SUBJECT: PLANS AND PROPOSAL ADDENDUMS

PROJECT: F 2025(482)

CONTROL: 0047-05-057

PROPOSAL ADDENDUMS

**SPUR 399
 RETAINING WALL S39900
 PLAN AND PROFILE**

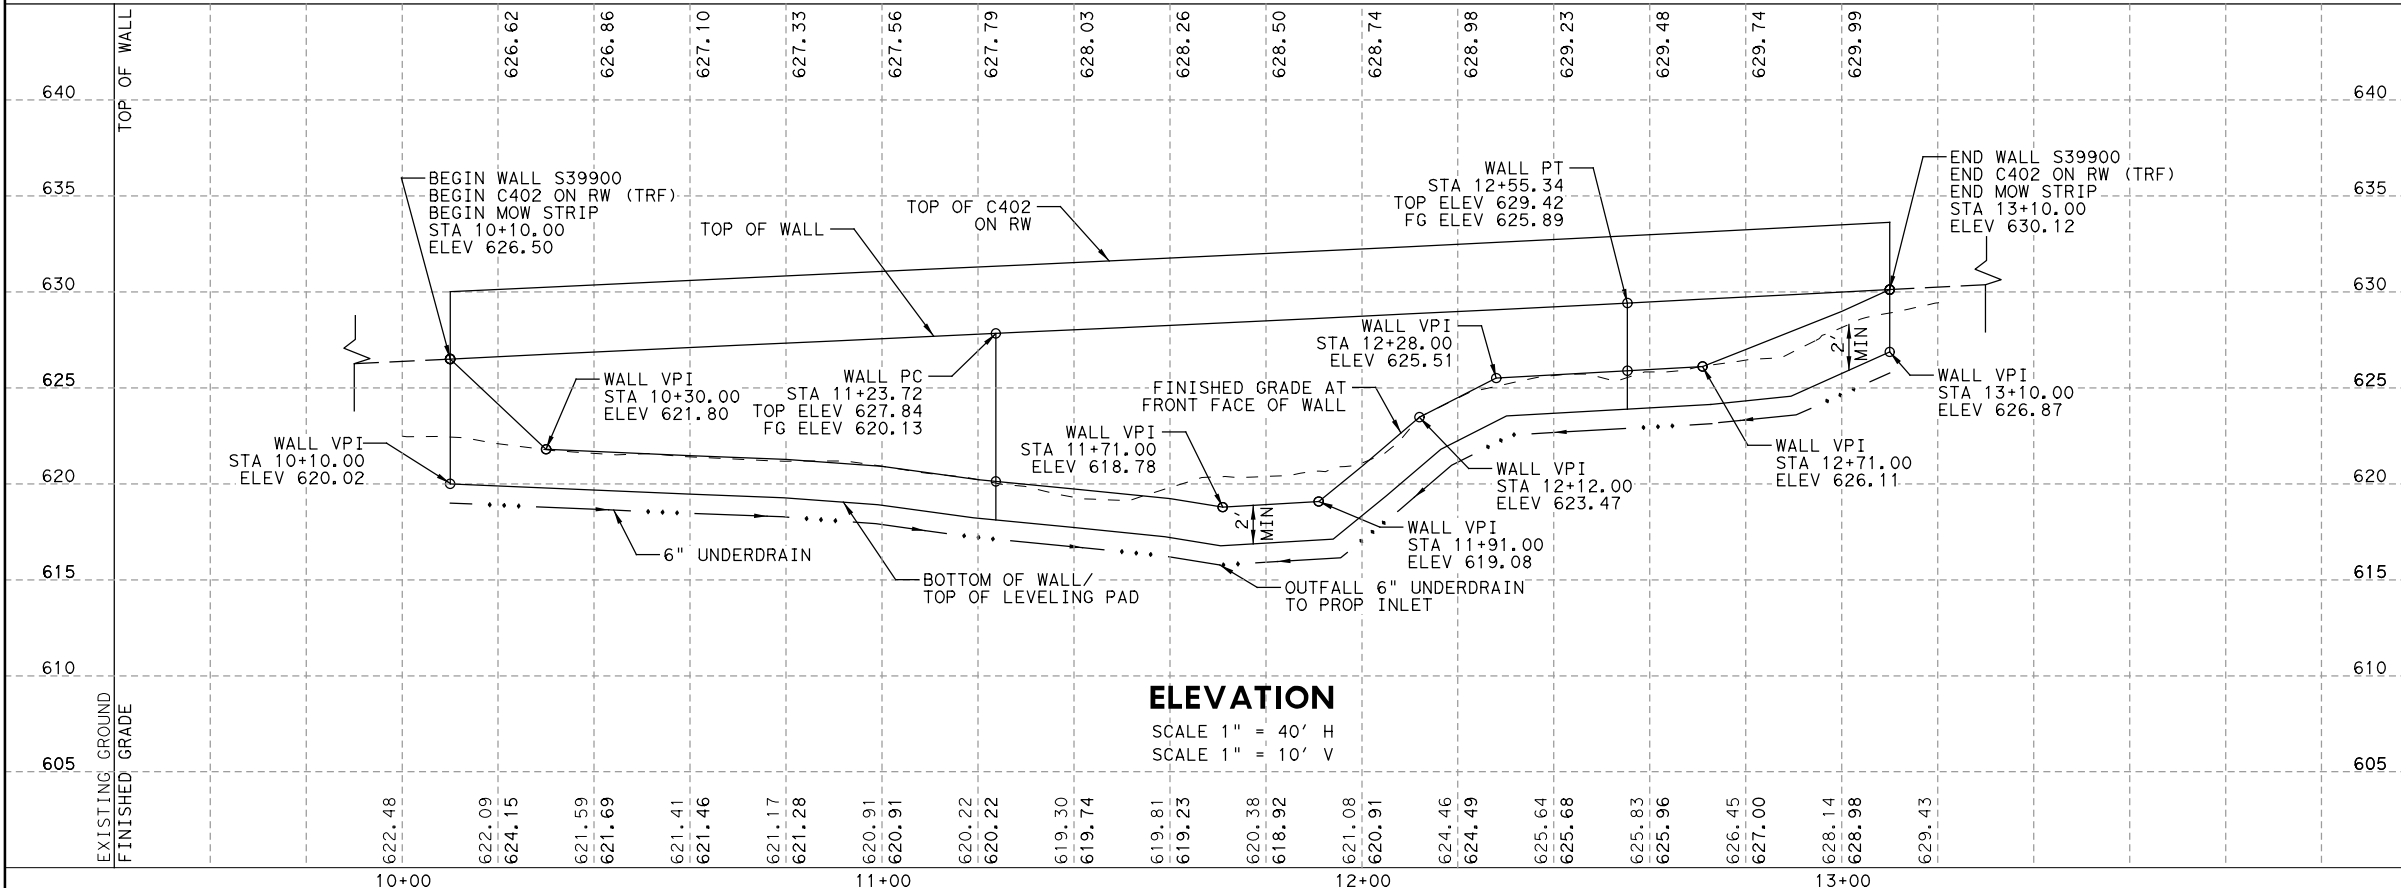
SHEET 567, 569, 571, 573, 585, 587, 588, 590,592, 594, 596, 597,
599, 601 , 603, 605, 607, 609, 610, 614, 615, 618, 619, 626,
627, 628, 635, 636, 638,640, 642, 643, 645, 647, 649, 651, 653,
654, 656, 657, 659, 661, 663, 664, 666, 668, 670, 672, 674,
676, 677, 679, 680:REVISED SHEETS DUE TO ADD BID ITEM 556-7006.
